INSTRUCTION TO SERVICE

ITS: 5666

SECTION:	526 Seating and Stanchions
WRITTEN BY:	Kevin Robinson
SUBJECT:	Remove lower barrier panels at the exit door and replace.

Figure 1: Barrier panels at rear exit door.

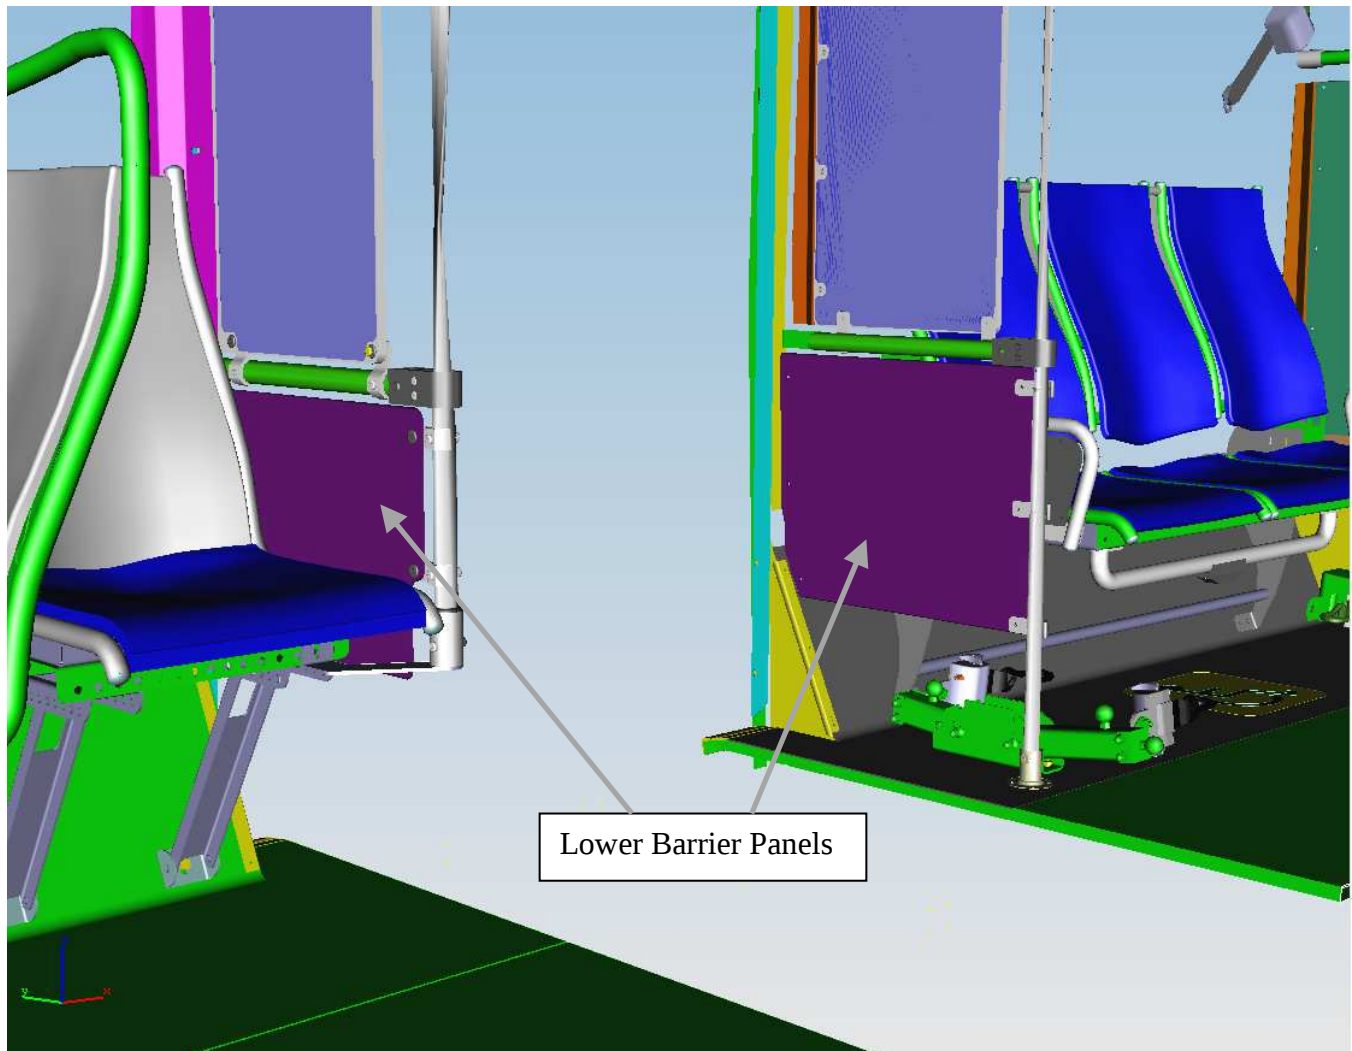
1. Turn the main battery disconnect switch to the “OFF” position.
2. Remove the existing lower barrier panels from the bus, located forward and rearward of the exit door. Retain hardware for re-use.

3. Install the new forward barrier panel (NF PN 547905) in the location the previous one was in. Secure with existing hardware. Apply 1 to 2 drops of Loctite to threads of hardware prior to securing.
4. Install the new rear barrier panel (NF PN 547900) in the location the previous one was in. Secure with existing hardware. Apply 1 to 2 drops of Loctite to threads of hardware prior to securing.
5. Remove all tools and debris and return the bus to service condition.
6. Turn the main battery disconnect switch to the “ON” position.
